Access Compliance Report

Public Rights-of-Way

(Curb Ramps)

Intersection ID: 16745	Main Street: MARYLAND_AV	Cross Street: PRINCETON_AV	Location: NW
ADA ID: F82BDBE34DA2	Ramp Type: PerpDiag	Initial Pass/Fail: Fail	Overall Compliance: No
			Severity Score: 13.75

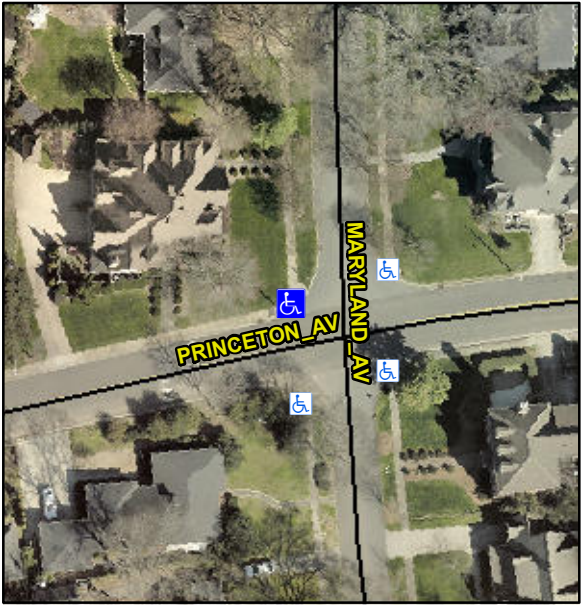
Codes/Mitigation Info/Possible Solution			Field Measurements/Component Compliance		
	Possible Solutions:		Compliance	Description	Data
	Remove & Replace Curb Ramp With Two New Directional Ramps or Equivalent.		No	Ramp Length (in)	86.0
			Yes	Ramp Width (in)	48.0
			N/A	Flare Type LT	N/A
			N/A	Flare Slope LT (%)	N/A
			N/A	Flare Traversable LT?	N/A
			N/A	Landing Length (in)	N/A
			N/A	Landing Width (in)	N/A
			N/A	Landing Slope (%)	N/A
			N/A	Landing X Slope (%)	N/A
<p>Surveyor Notes:</p> <p>N/A</p> <p>PROW/ADA:</p> <p>R304.2.2, R304.5.3</p>			N/A	Flare Type RT	N/A
			N/A	Flare Slope RT (%)	N/A
			N/A	Flare Traversable RT?	N/A
			N/A	DWS Provided?	N/A
			N/A	DWS Contrast?	N/A
			N/A	DWS Length (in)	N/A
			N/A	DWS Full Width?	N/A
			N/A	DWS Offset (in)	N/A
			N/A	Gutter Ponding?	N/A
			N/A	Gutter Lip Ht (in)	N/A
<p>Total Cost:</p> <p>\$ 3200.00</p>			No	Painted X Walk2?	No
			To S	X Walk 2 Direction	To E
			N/A	X Walk 2 Width (in)	N/A

0.7	X Walk 2 Slope (%)	4.3
			4.1	X Walk 2 X Slope (%)	1.1
			N/A	Ramp inside XWalk2?	N/A
			3.9	Clear Space?	N/A
			2.8	Clear Space to XWalk (in)	N/A
			N/A	Storm Grate/Utility Hazard?	N/A
			N/A	Storm Grate/Utility Type	N/A
			N/A	Surface Condition? (G/P)	Good
